Access Compliance Report

Public Rights-of-Way

Intersection ID: 12516	Main Street: ARTY_AV	Cross Street: W_MOREHEAD_ST	Location:	N
ADA ID: 95C0F944EAA5	Ramp Type: Perp	Initial Pass/Fail: Fail	Overall Compliance: No	Severity Score: 10

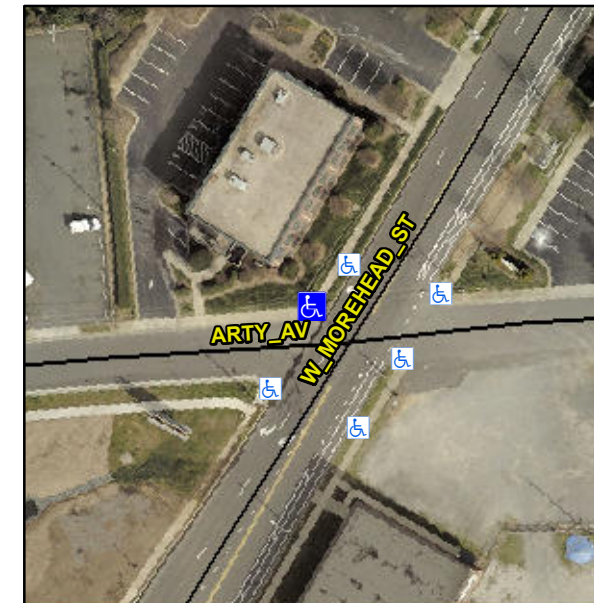
Not Found, R304.5.1, R304.5.3

Compliance	Description	Data	Compliance	Description	Data
N/A	Ramp Length (in)	61.0	Yes	Ramp Slope (%)	6.1
No	Ramp Width (in)	47.0	No	Ramp XSlope (%)	3.3
N/A	Flare Type LT	N/A	N/A	Flare Type RT	N/A
N/A	Flare Slope LT (%)	N/A	N/A	Flare Slope RT (%)	N/A
N/A	Flare Traversable LT?	N/A	N/A	Flare Traversable RT?	N/A
N/A	Landing Length (in)	N/A	N/A	DWS Provided?	N/A
N/A	Landing Width (in)	N/A	N/A	DWS Contrast?	N/A
N/A	Landing Slope (%)	N/A	N/A	DWS Length (in)	N/A
N/A	Landing X Slope (%)	N/A	N/A	DWS Full Width?	N/A
N/A	Landing Curb? (Y/N)	N/A	N/A	DWS Offset (in)	N/A
N/A	Shared Landing?	N/A			
N/A	Gutter Ponding?	N/A	N/A	Gutter Slope (%)	N/A
N/A	Gutter Lip Ht (in)	N/A	N/A	Gutter X Slope (%)	N/A
N/A	Painted X Walk1?	No	N/A	Painted X Walk2?	N/A
	X Walk 1 Direction	To SW		X Walk 2 Direction	N/A
N/A	X Walk 1 Width (in)	N/A	N/A	X Walk 2 Width (in)	N/A
	X Walk 1 Slope (%)	1.8		X Walk 2 Slope (%)	N/A
	X Walk 1 X Slope (%)	4.6		X Walk 2 X Slope (%)	N/A

Remove & Replace Entire Ramp.
